Planning Application APP/22/00903 - Response to objections

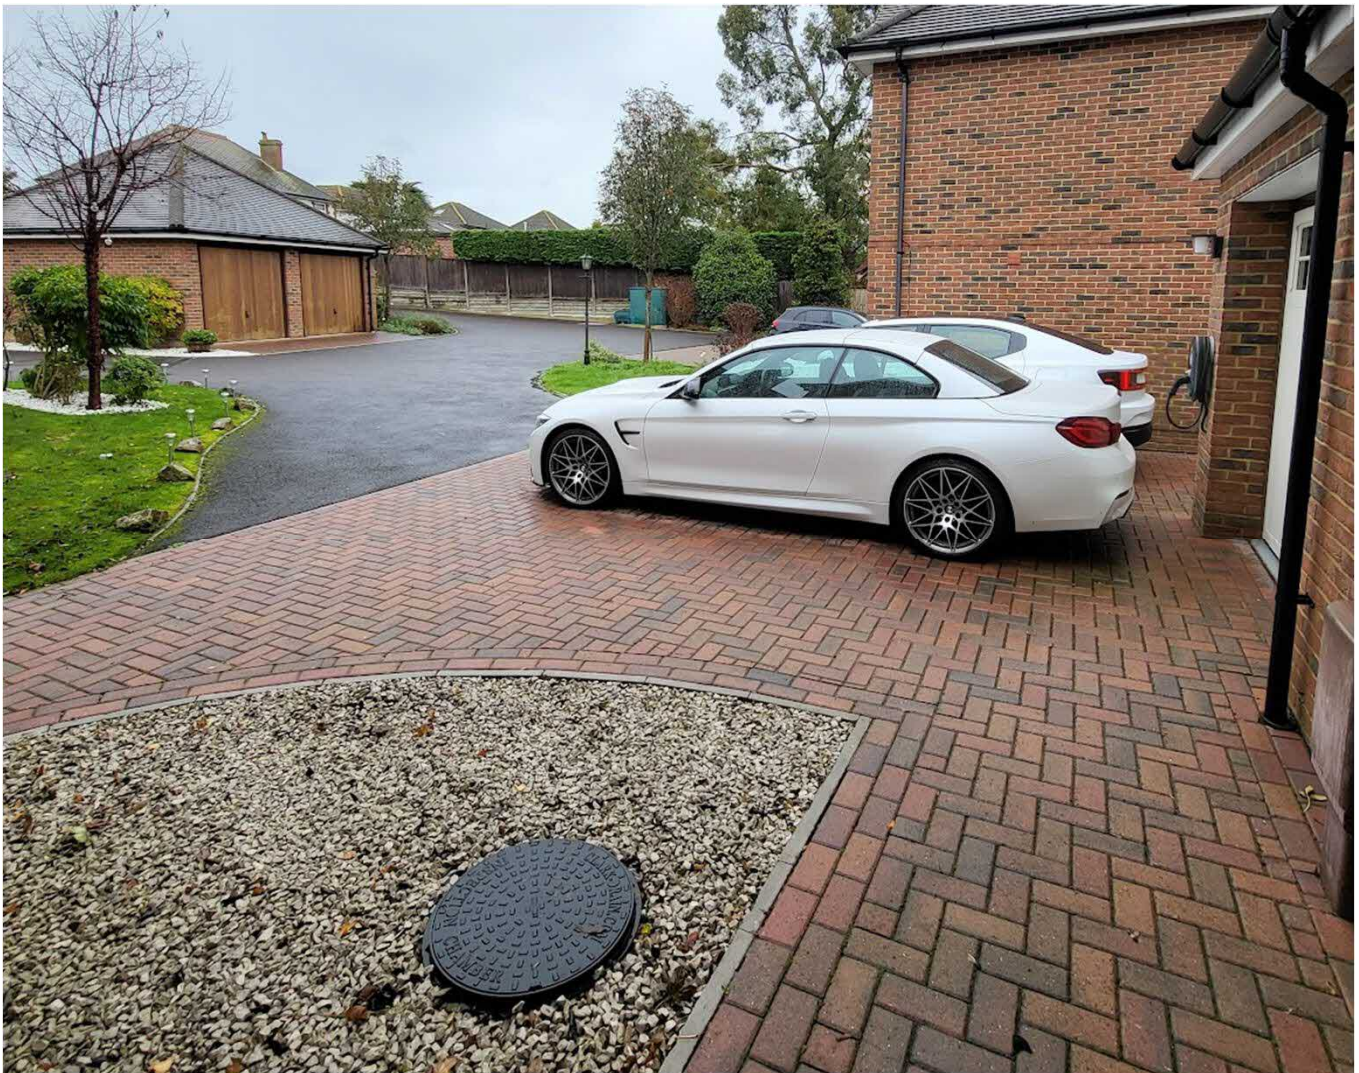
1. The extension to Mr Hogg's drive to accommodate an extra 2 cars. This means he is attempting to park 3 cars width ways. This is not possible without encroaching neighbour's land either side to access vehicles.

The additional parking space at the front has been in existence for approx. 3 years and in that time it has been regularly used by the family. At no time have our vehicles encroached onto the property of No 4 or No 2. Moreover, it is not possible to do so without seriously damaging ones own vehicle due to the siting of several large boulders around No 4 boundary. (see below image)

In order to drive into the additional space, our vehicles drive in on an angle and this has not caused our neighbours any problems.

The other 3 spaces (Central ,adjacent to No 2 and adjacent to garage) were existing.

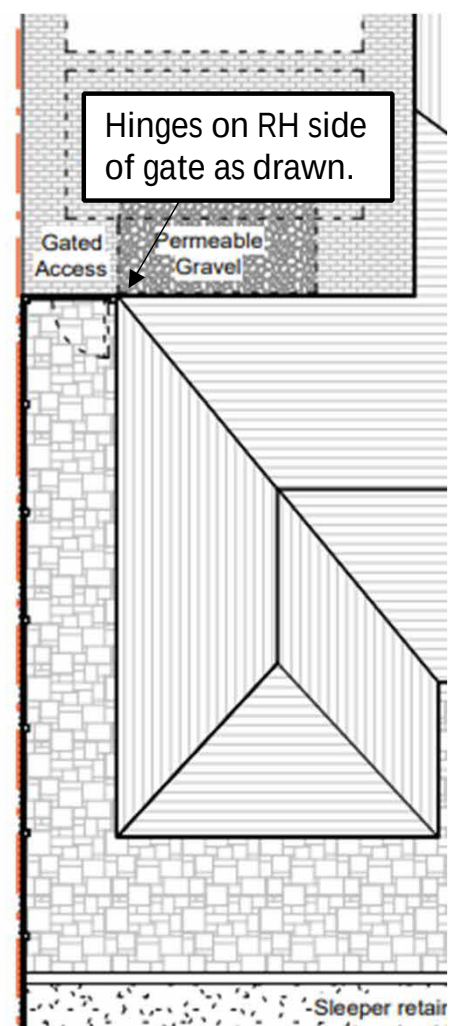
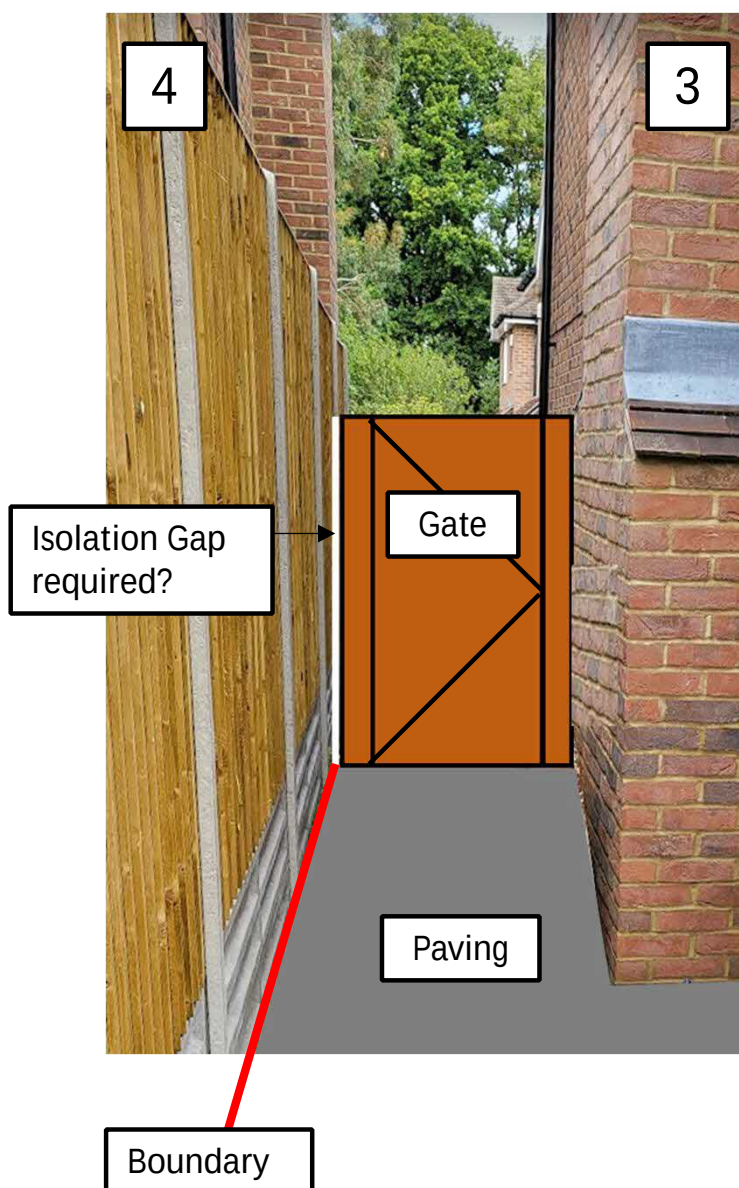
2. The boundary between 3 and 4 is owned by number 4, There have never been access gates here. The boundary fence was recently replaced by number 4 with Mr Hogg aware and in agreement to the replacement. We object to a gate being attached to the existing boundary.

The responsibility of No 4 to maintain the fence between 3 & 4 (western boundary) is shown on the title deeds and is not in dispute.

If the objection relates to the joining of the gate to existing boundary for maintenance reasons, then it is possible to construct the gate entirely within No 3 boundary leaving a small isolation gap, should the planning dept agree.

Although it is more work than joining to existing fence corner post, it is not a major issue to do so as shown by below concept image.

We will be guided by the planning dept on this matter.

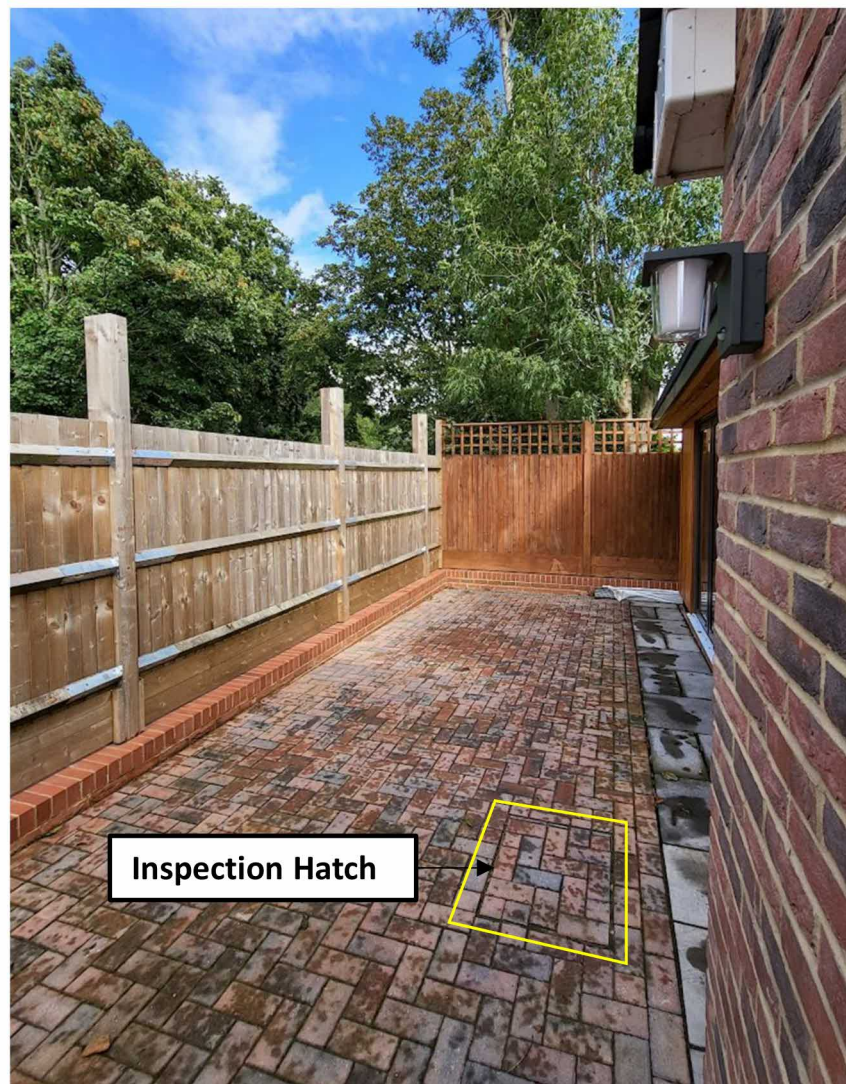
14. The additional parking will also impact on the drainage system due to underground pipes that need to be accessible as the water flows down from no 3 into no 1 which has all 3 access points, potentially this would create build up of waste etc if not properly managed.

It is assumed that this comment is directed to extended drive as it would not be relevant to additional parking space at the front for obvious reasons.

Therefore: During design and build of the extended drive, it was noted that there was only one inspection chamber within the area of the drive.

This inspection chamber remains and is still fully accessible, with block paved hatch.

From plans of drains on page 9 it can be seen (in Blue) the routes of the various storm drainage. Foul Water (in Red) is totally unaffected by any works carried out.

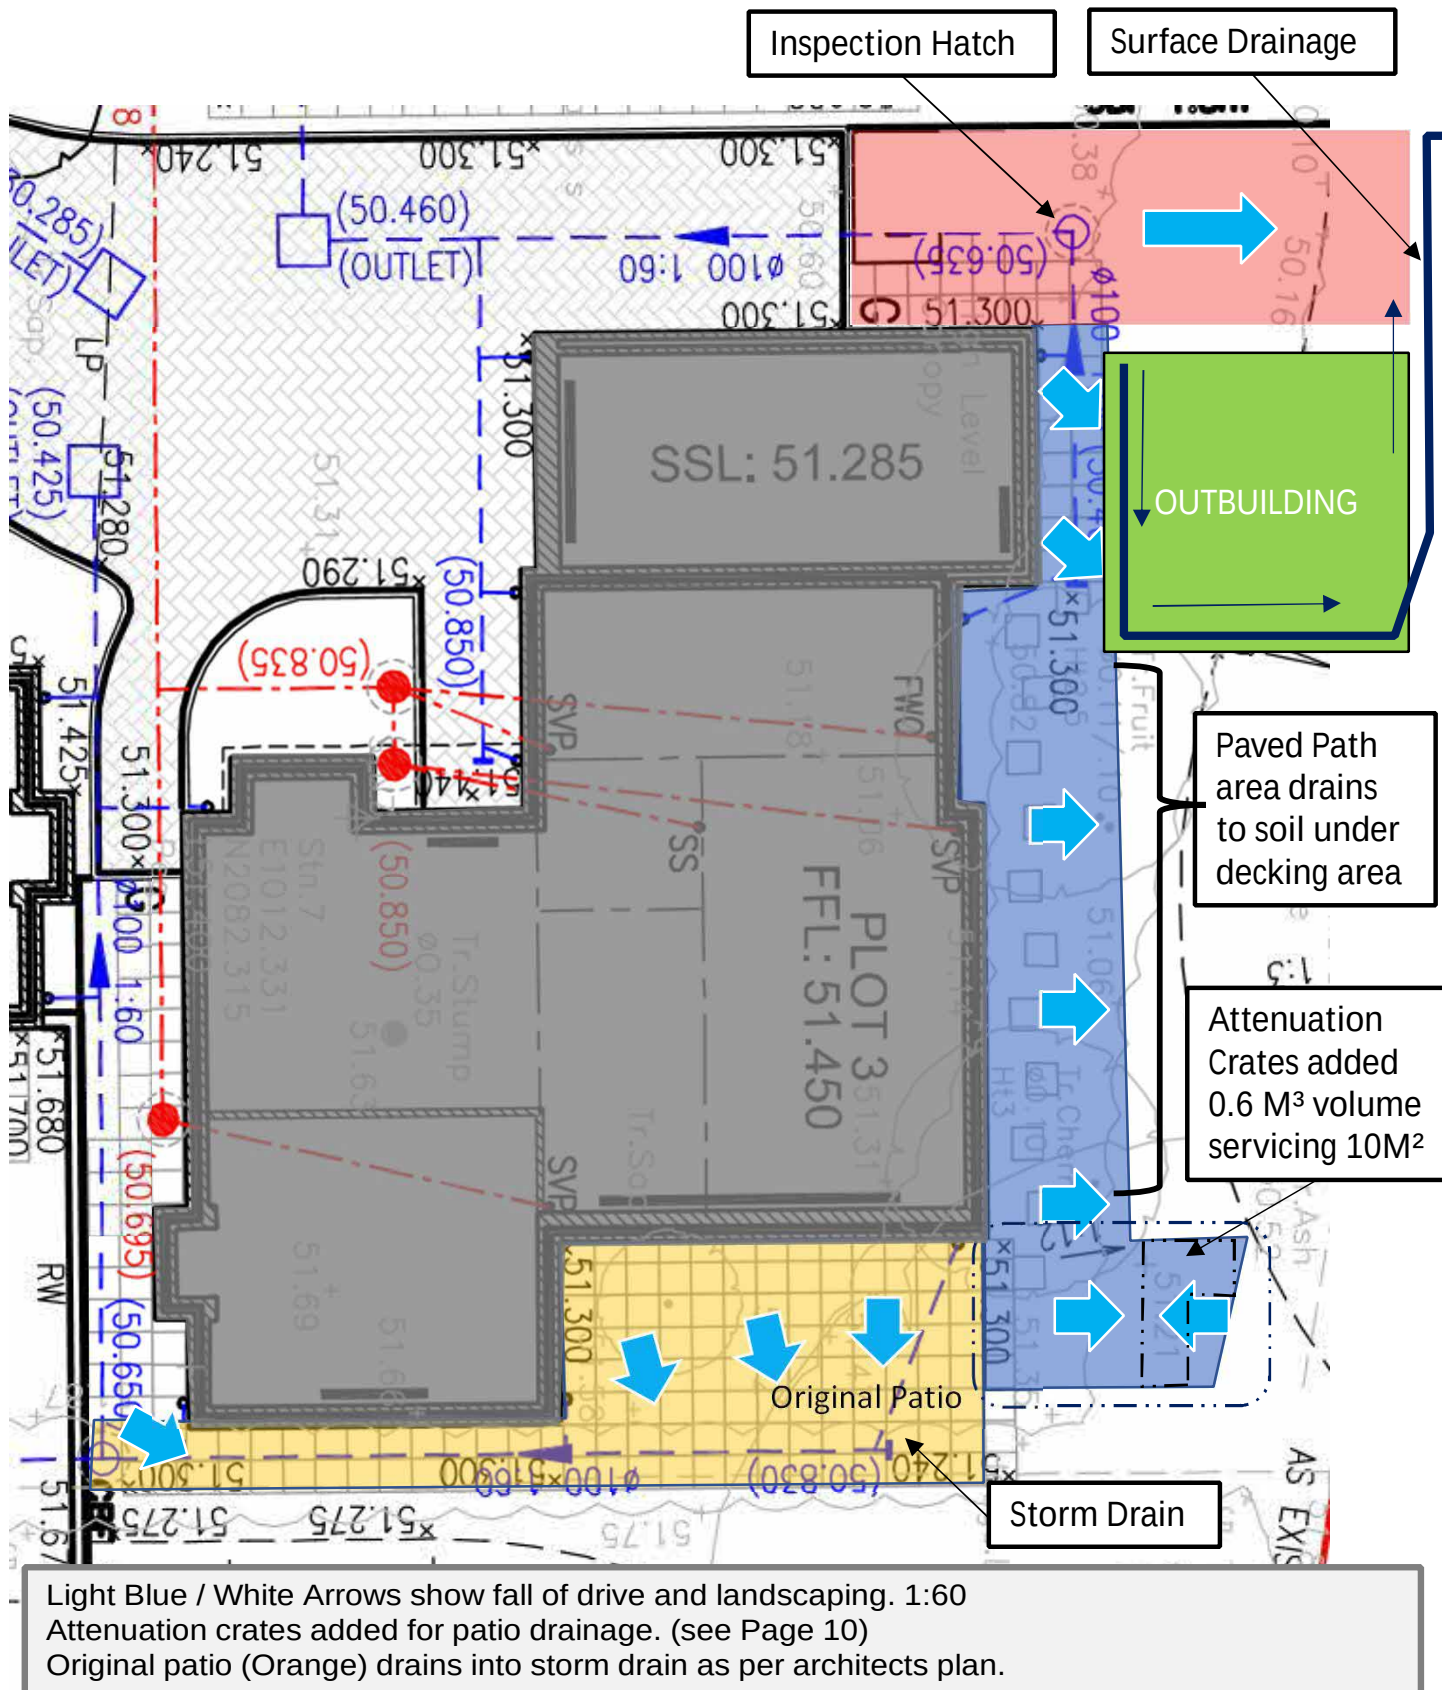
11. We have been advised and ask you to investigate the extended drive which states permeable replacements and paving? If no drainage has been installed when the drive was extended it can cause a buildup of flood water which can affect neighbouring properties.

Surface Drainage
installed – see page 9

Additional drainage on patio area – 10M²

5 x Attenuation crates added (120 Litres each) = 600 Litres ($600,000\text{cm}^3 / 100,000\text{cm}^2 = 6\text{cm}$)
Therefore, 60mm depth of rain falling on patio area can be accommodated in the soak away.

Drain / trap added to feed attenuation
crates – This area to proposed to be
slabbed to match existing paved path
per planning application.
